PG160-B02

8GB GDDR6, 256b, X16
Tall DVI-D + USBC/DP + DP + HDMI/DP + DP

MS-V375

Page3: PCI Express

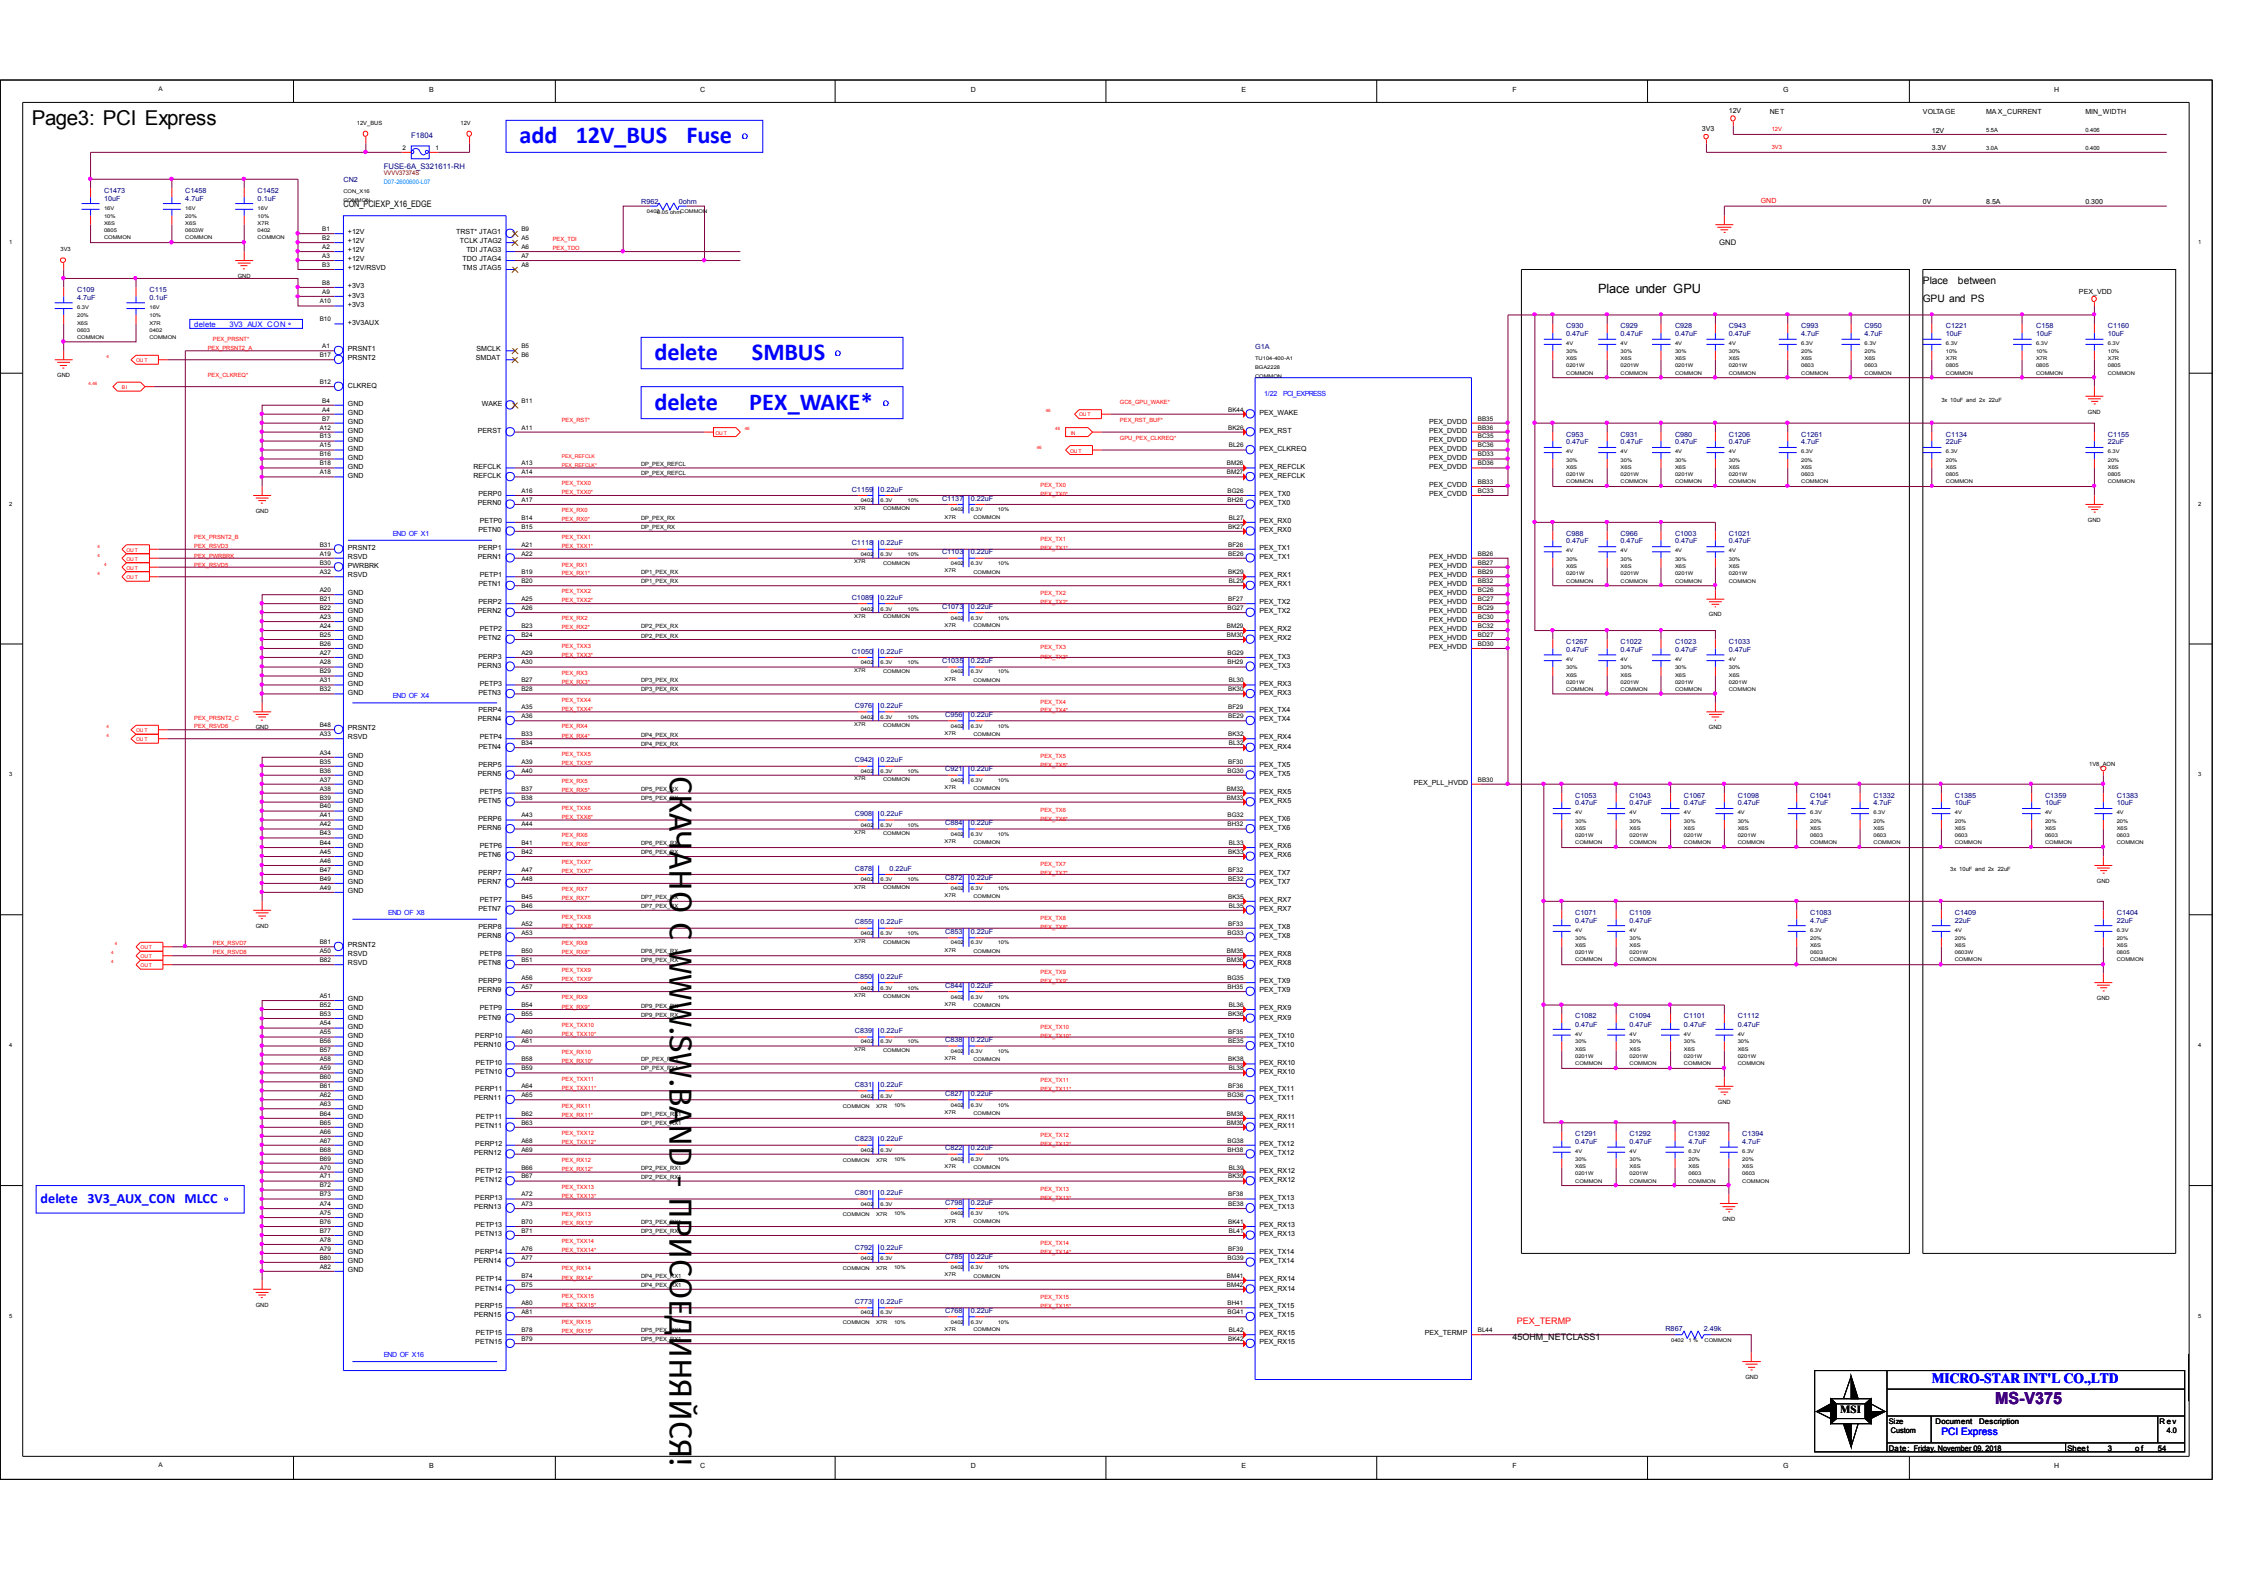
add 12V_BUS Fuse

delete SMBUS

delete PEX_WAKE*

delete 3V3_AUX_CON MLCC

Page18: IFPAB DVI-D-DL

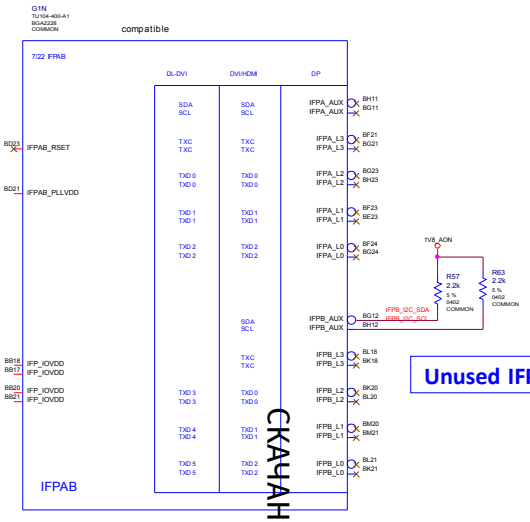
delete Link AB ◦

Unused IFPB_I2C* leaving Pull high resistor to 1.8V ◦

Page20: IFPF USB-C

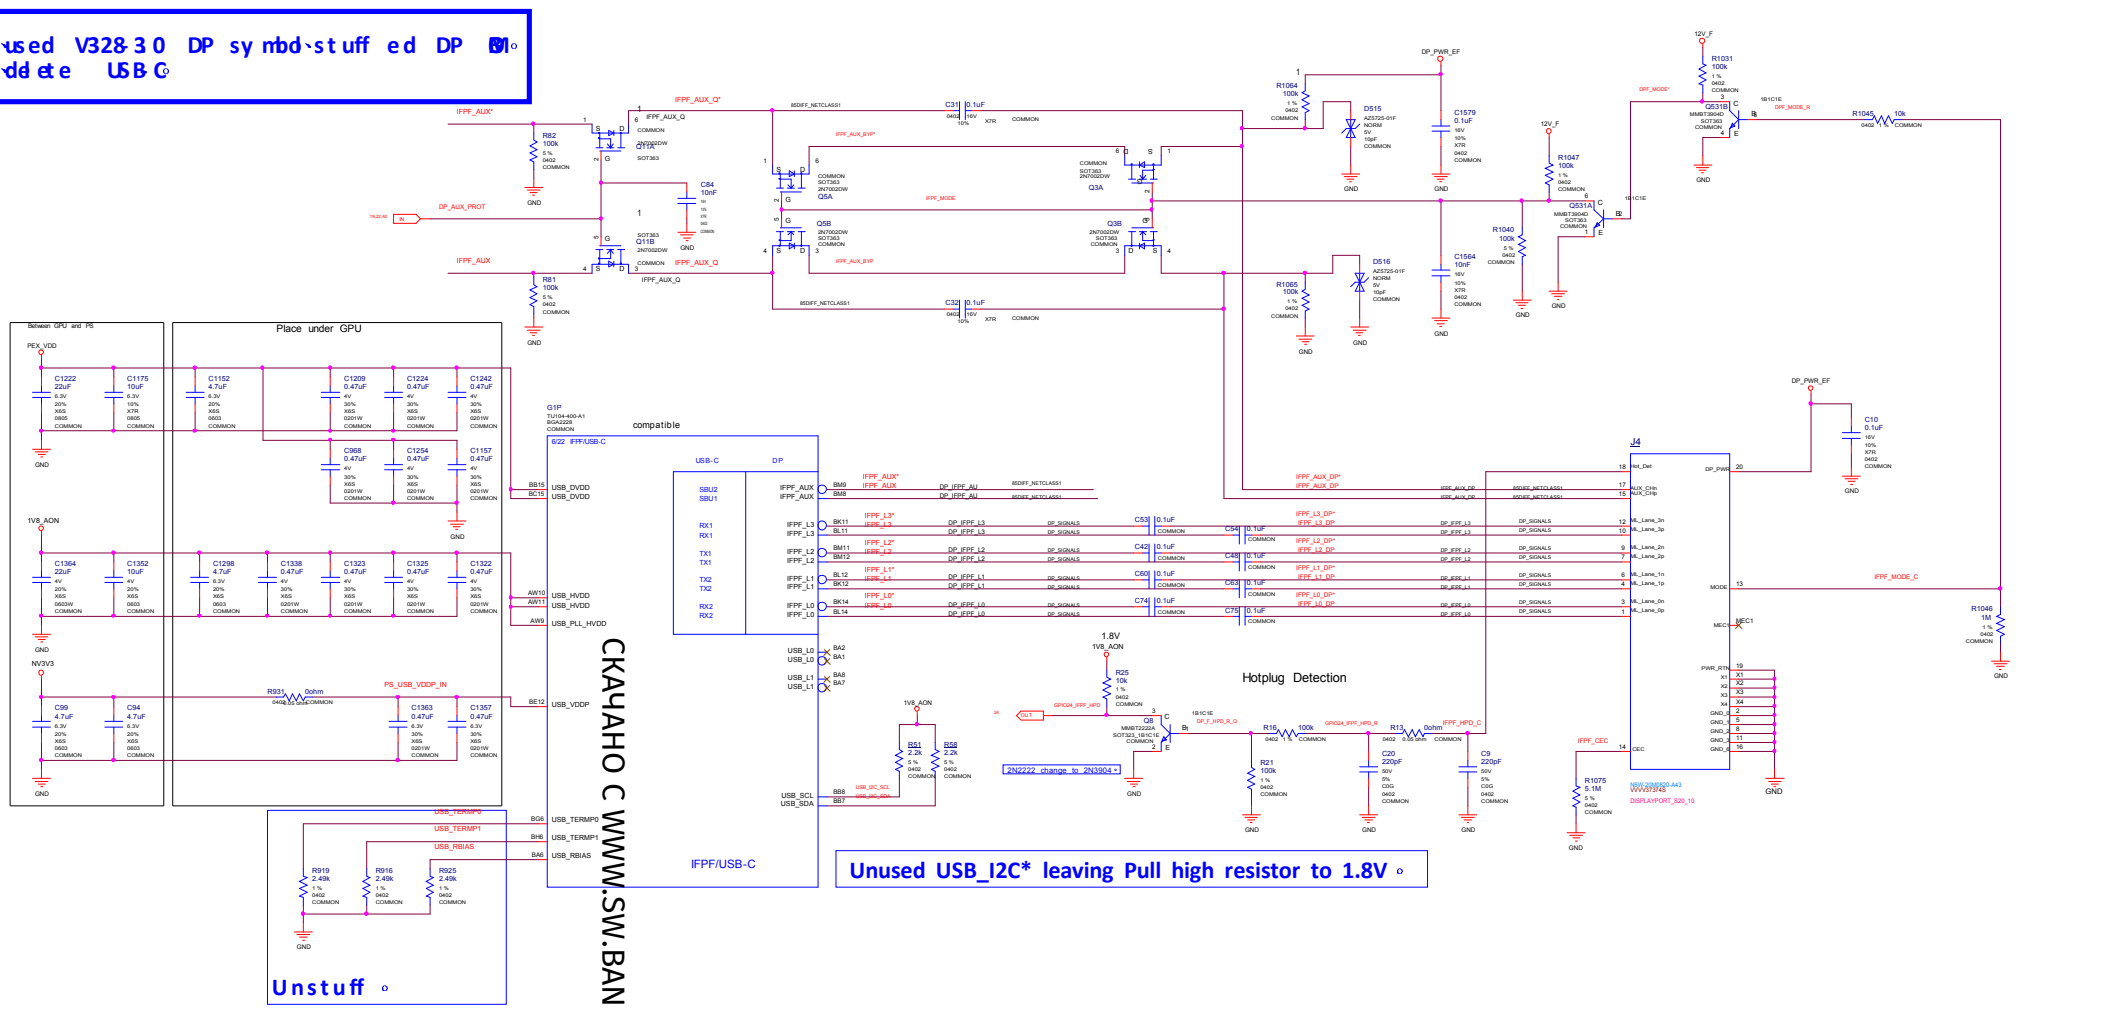
1 used V328-30 DP symbol stuff ed DP MUX
2 added USB-C

Page21: IFPC HDMI/DP

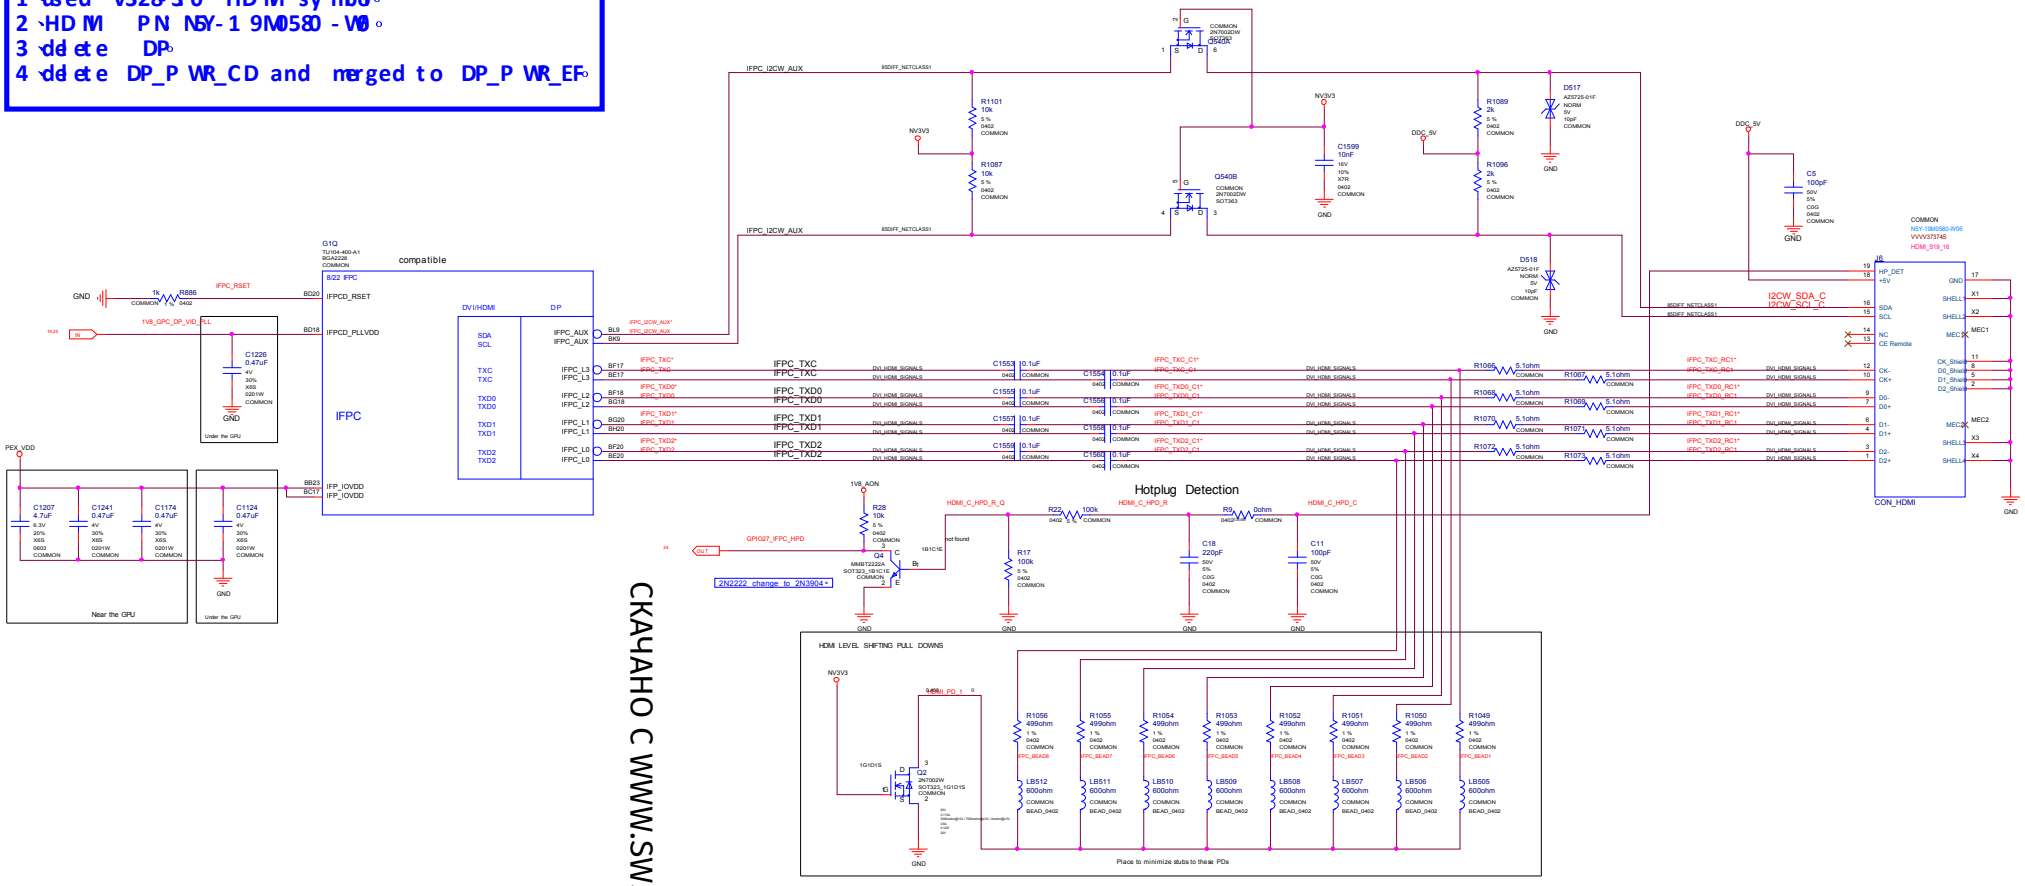
1 used V328-30 HDMI symbol.
2 HDMI P/N MSY-19M0580-W0.
3 delete DP.
4 delete DP_PWR_CD and merged to DP_PWR_EF.

Page23: NVHS Interface and Frame Lock

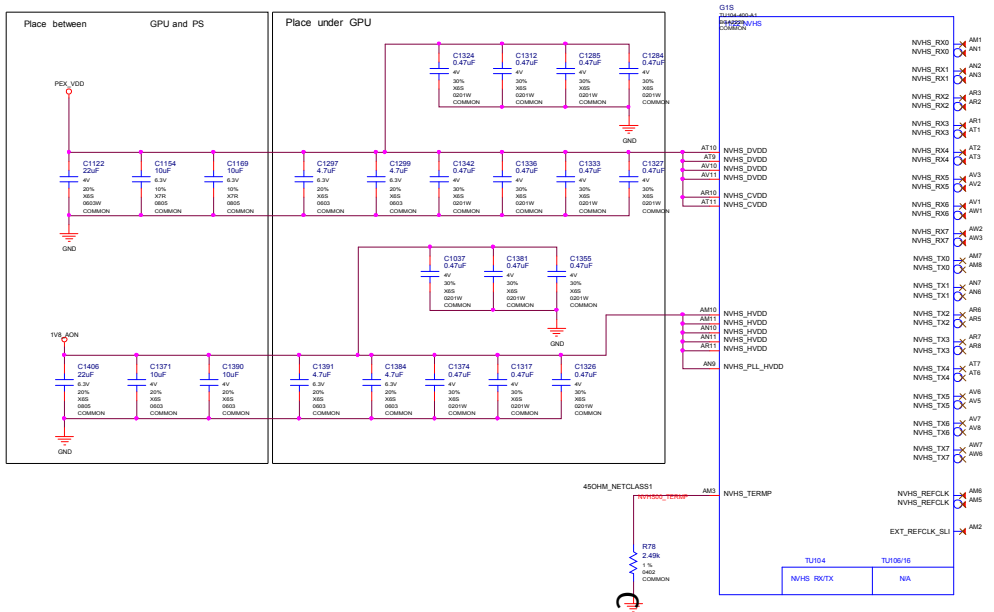
delete Frame Lock ◦

Page24: MISC1: Fan, Thermal, JTAG, GPIO

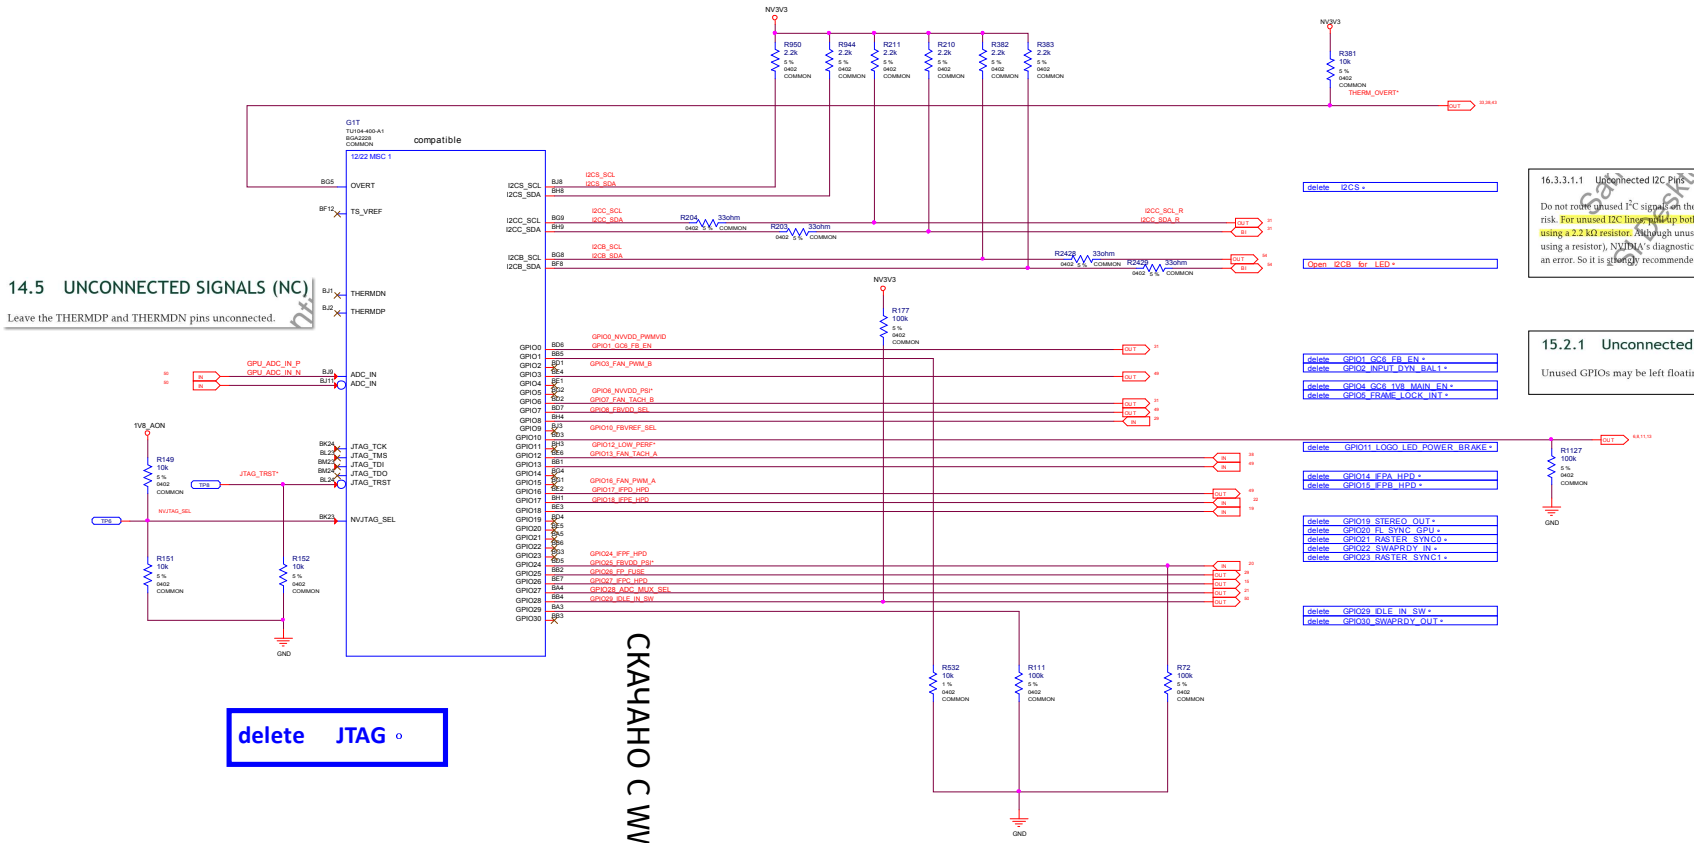
delete JTAG ◦

Unused delete GPIO11_LOGO_LED_POWER_BRAKE ◦

Unused delete STEREO ◦

Page26: PS: 1V8 PLL, 1V8_AON

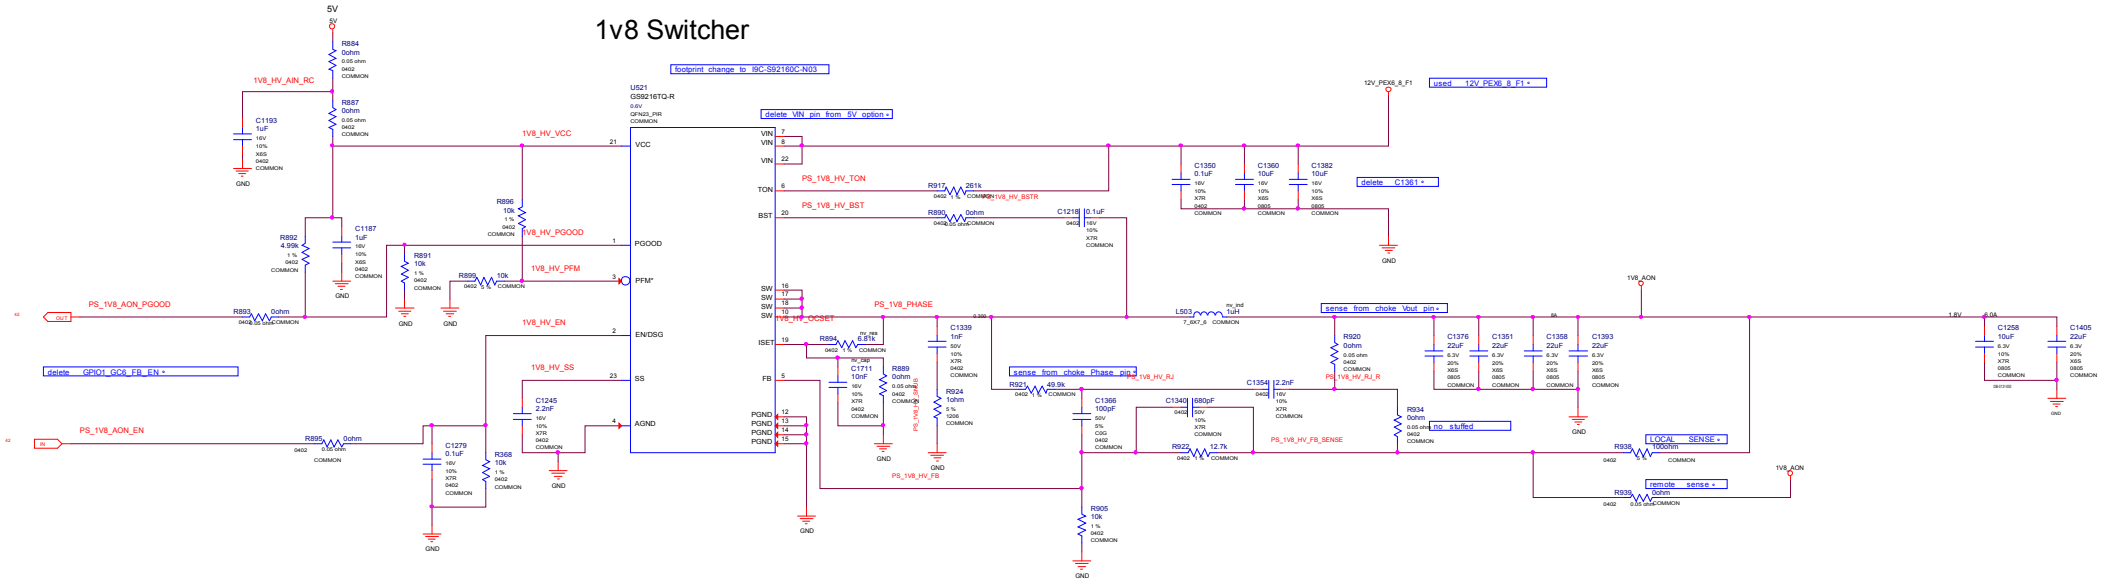
1 L503 PN L04-010740-L65 / footprint : CHK_S2_3X6_61
2 delete colayout PWM ouput choke
3 delete 1V8_MAN and merged to 1V8_AON
